PLANNING COMMISSION MEETING
Tuesday, July 10, 2018, 6:30 PM
Council Chambers, 2nd Floor City Hall
1300 NE Village Street

File Number 2018-21-DR-CUP

Summary: The applicant is requesting Site Design Review and Conditional Use approval for a mixed use development at 20922 NE Sandy Blvd. The development will include new landscaping, 67 off-street parking spaces and a four-story mixed use building with 1,000 SF commercial space and 48 residential units.

**PLANNING COMMISSION STAFF REPORT
TYPE III SITE DESIGN REVIEW & CONDITIONAL USE PERMIT
FINDINGS AND STAFF RECOMMENDATION**

View Title: PEDESTRIAN SIDEWALK - PLAN

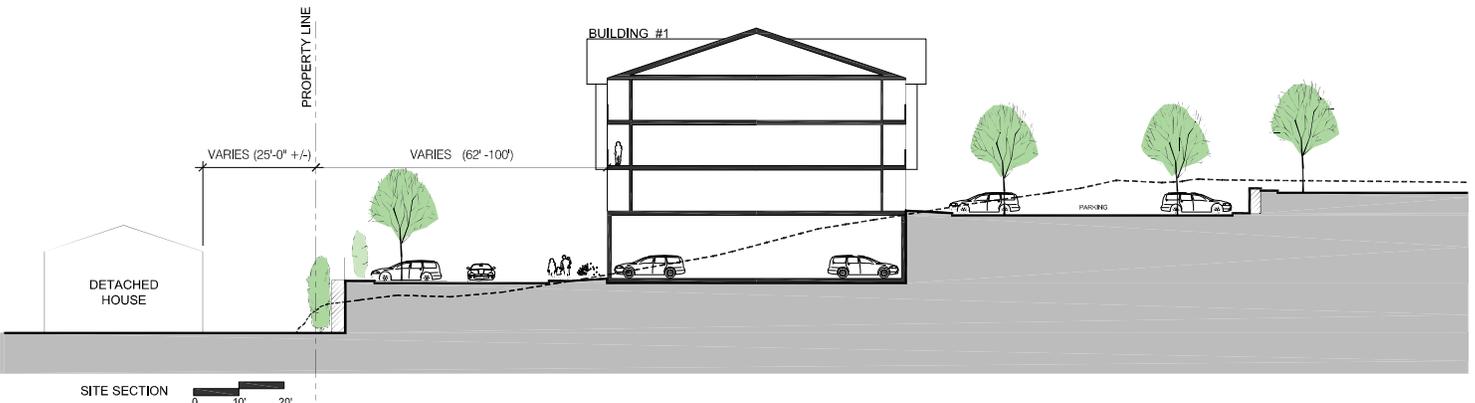
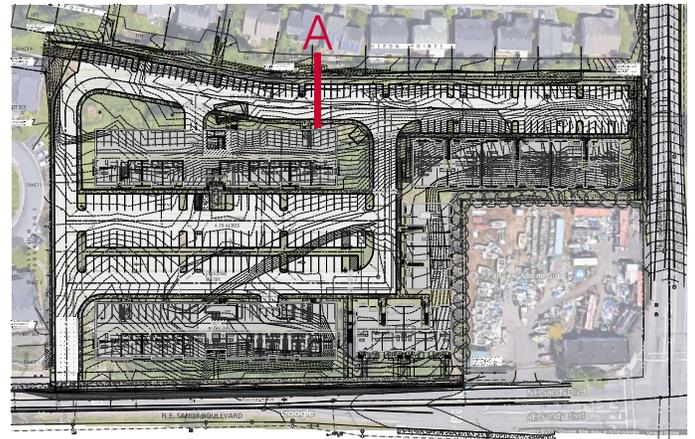
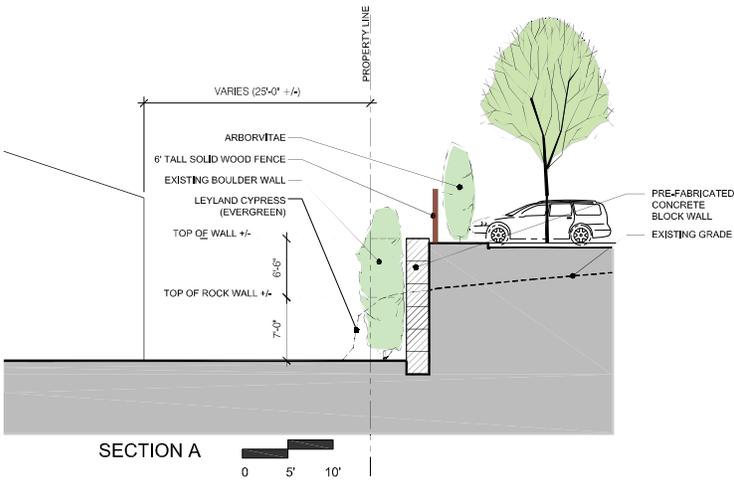
Project Architect Robert Leeb, Portland, OR reviewed the architectural aspects of the buildings. (*Exhibit B*) He requested the Commission allow the proposed five foot wide sidewalk in two areas (marked in orange on Pedestrian Sidewalk Plan in Exhibit B).

Chair Jones summarized the modification is to allow five foot wide interior walk ways, the applicant will submit revised drawings with additional landscape buffering in the upper north area of the site and additional shading to interior parking areas, and all other conditions are as written.

L-100

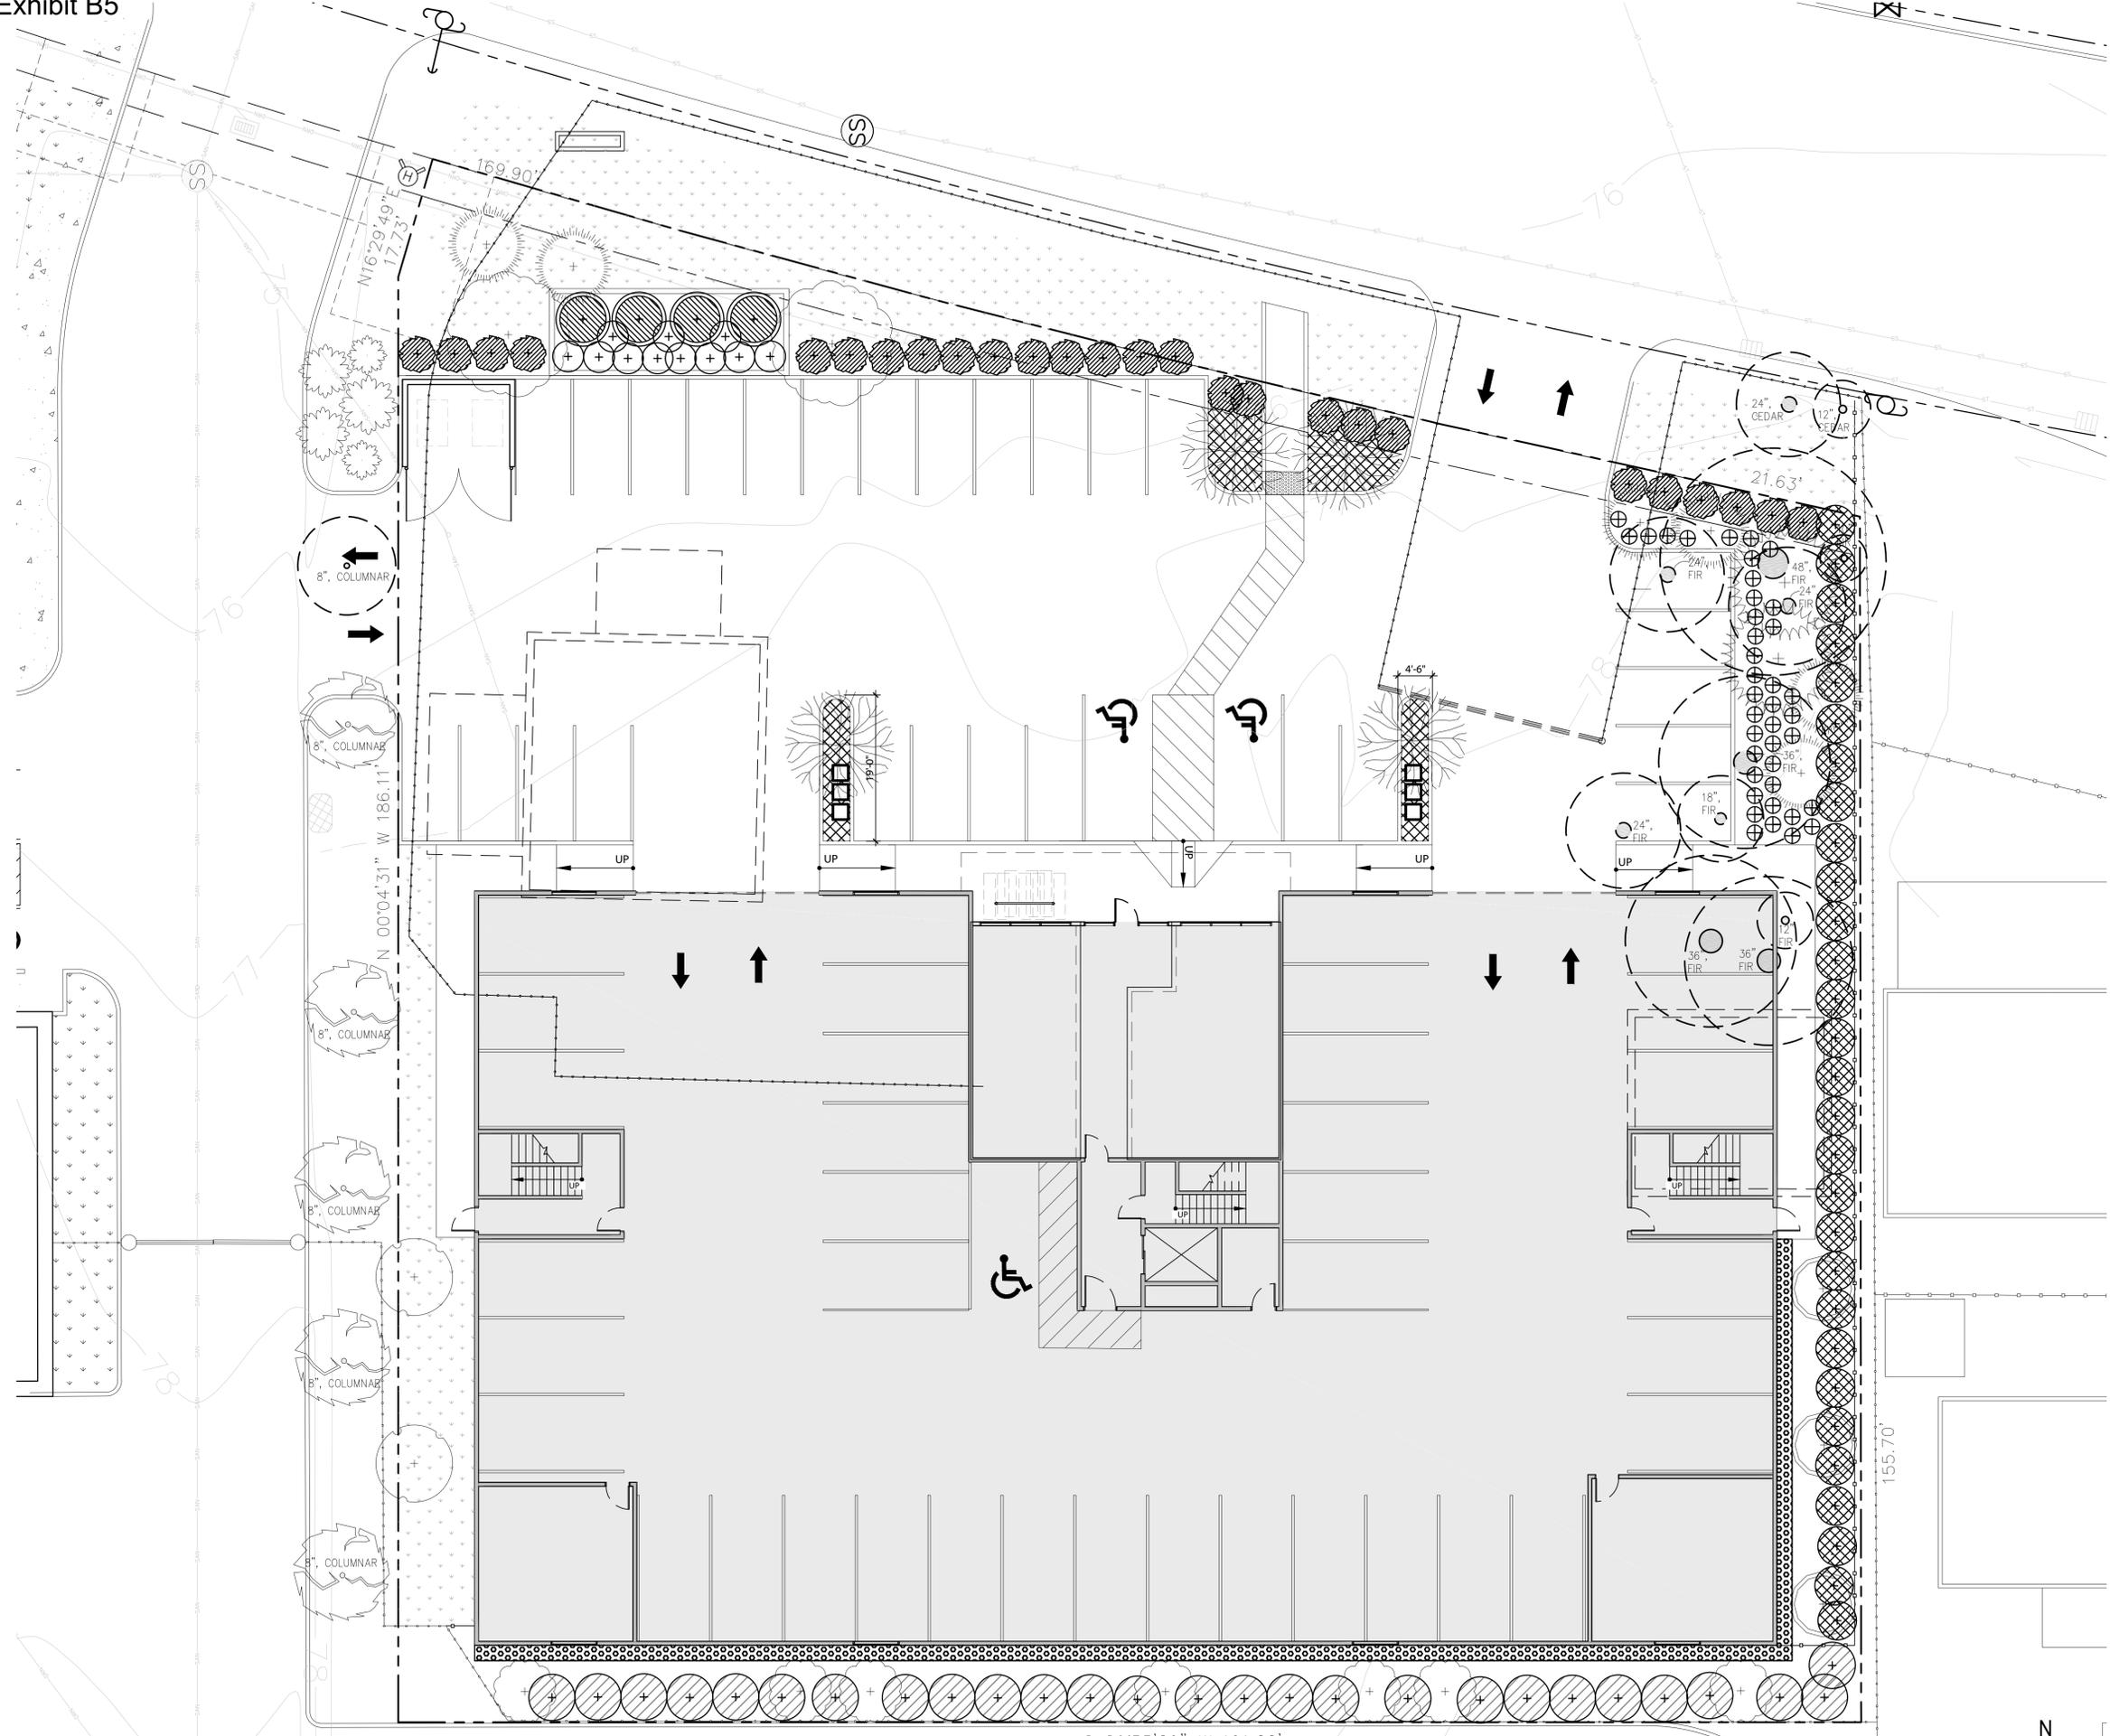
FINDINGS: The site plan (Exhibit B8) maps significant vegetation by type and size. A drip line is also included for each tree. The applicant is proposing to remove all of the existing trees on the site, and has not provided an assessment of the trees by a certified arborist to determine how the trees could be protected during development.

- Revise the landscape plan to add additional trees at regular spacing along the east side of the building to serve as a buffer between taller proposed building and lower abutting residential development. Buffer trees shall reach a mature height of at least 20 feet.

Condition of Approval: The following significant vegetation shall remain on site and be protected during and after construction. Prior to issuance of building permits, the applicant shall submit an arborist report and tree protection plan to ensure the health of these four trees prior to, during and after construction. Based on the tree protection plan, the site plan shall be revised and the location of parking and other improvements moved in order to protect the significant vegetation. Should the arborist report find that any of the following trees are diseased or dying, mitigation shall be proposed for city review in lieu of preservation.

1 PROPOSED SITE PLAN
 SCALE: 1"=10'-0"

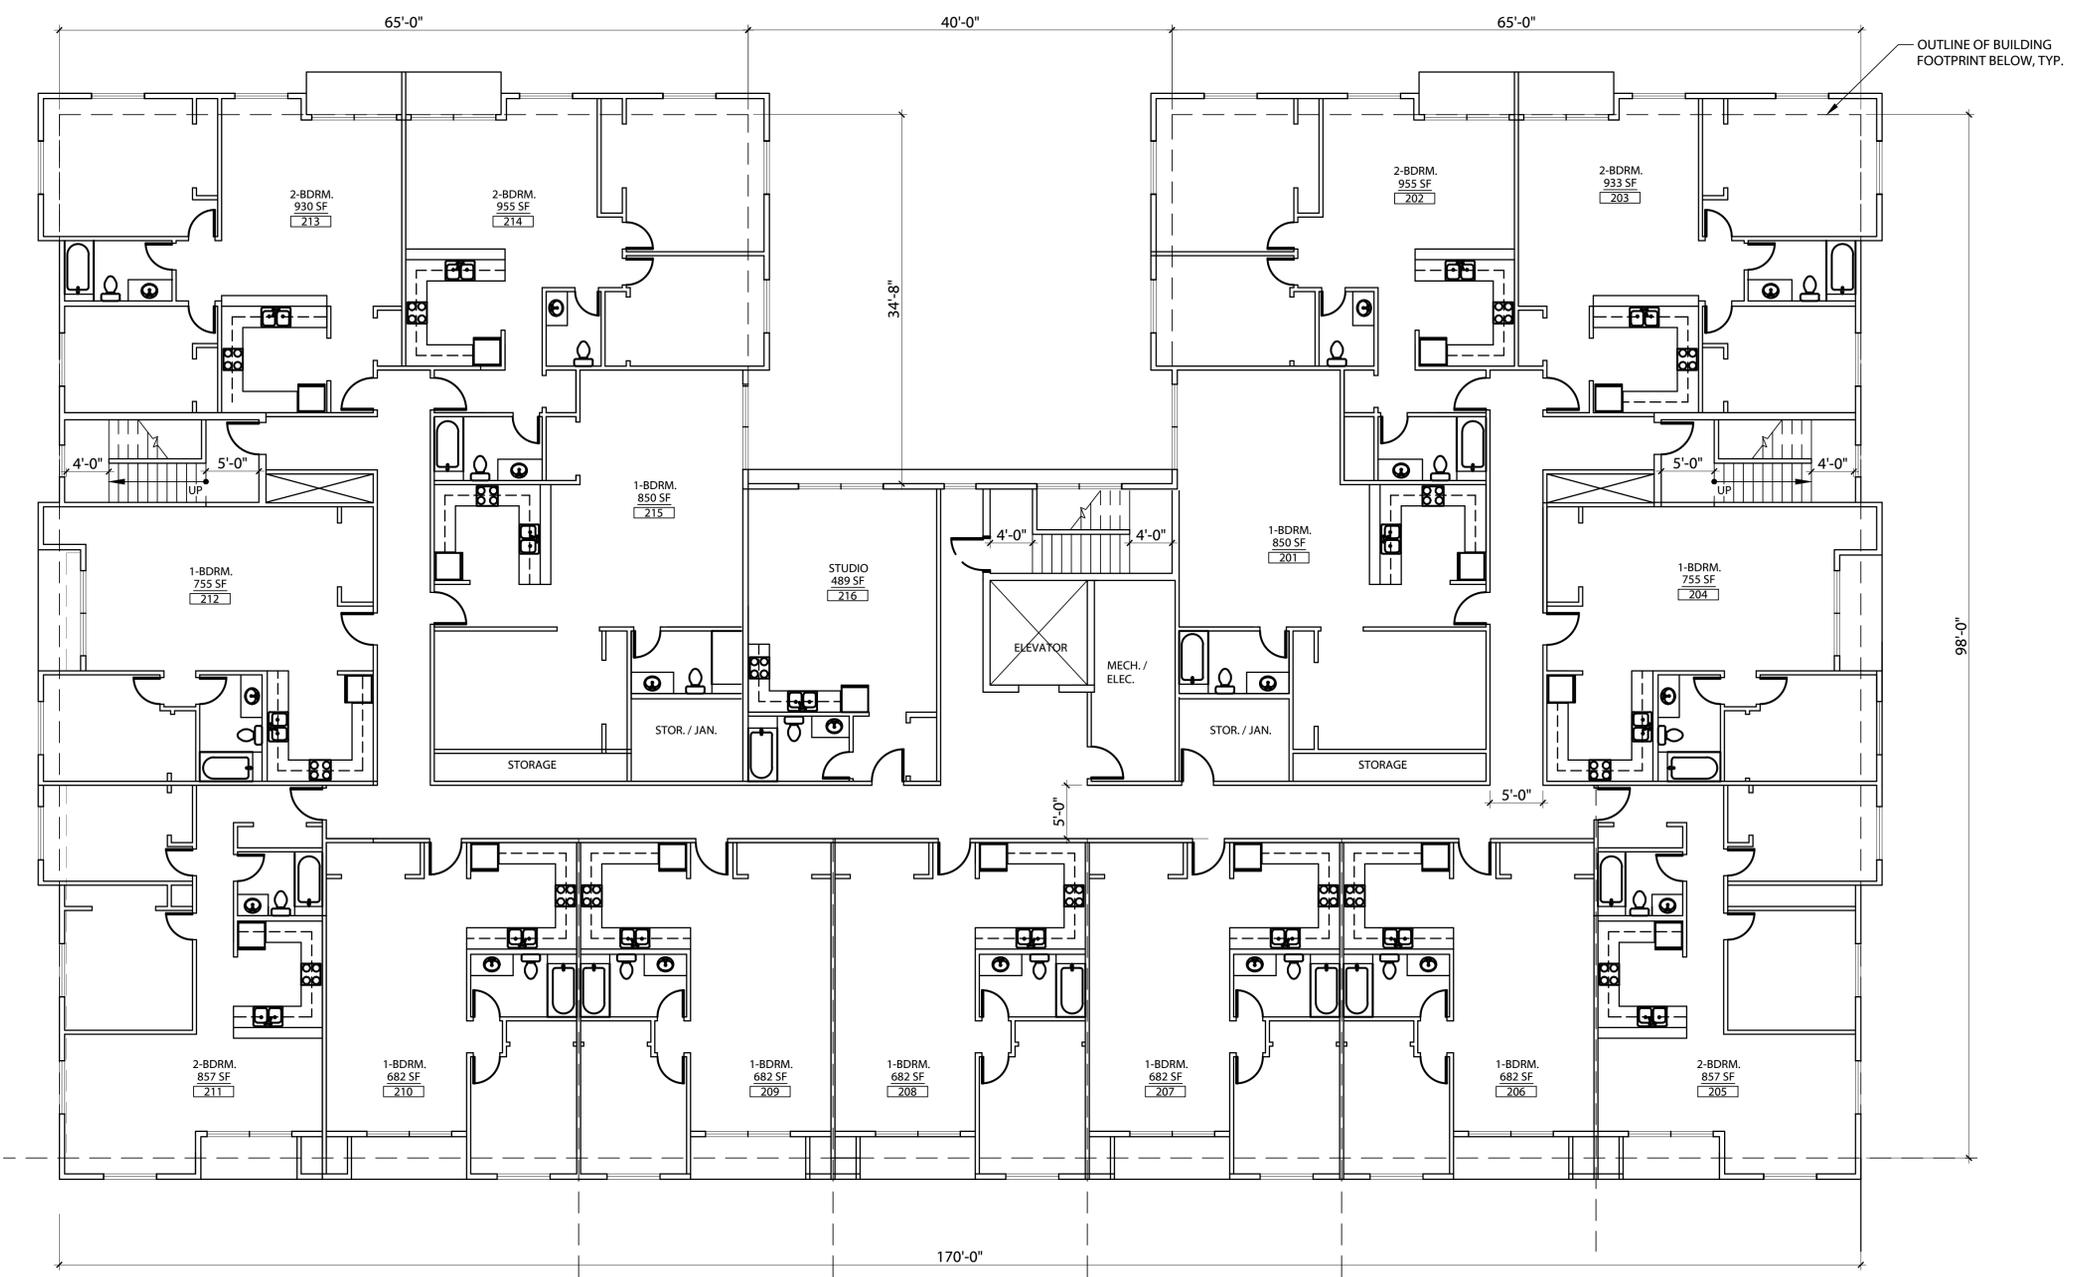
FINDINGS: The street frontage along Sandy Blvd. is 192 ft. A 5 ft. wide pedestrian pathway connecting Sandy Blvd. to the parking area and building entrance is provided approximately 112 ft. east of the western property line. The proposed site plan does not meet the 100 foot maximum interval for pedestrian pathway access from Sandy Blvd. See Exhibit B8 Site Plan.

FINDINGS: A total of 27 of the 67 parking spaces (40.3%) are proposed to be compact. This exceeds the allowed limit of 40%. All proposed compact, standard, and disabled spaces meet the dimension standards of the code. See Exhibit B8 Site Plan.

Conditional of Approval: Relocate the 5 ft. wide pedestrian pathway from Sandy Blvd. to the approximate middle of the street frontage to provide access at 93.5 ft. from each property line. Alternatively, provide a secondary pedestrian access from Sandy Blvd. to meet the 100 ft. maximum interval requirement.
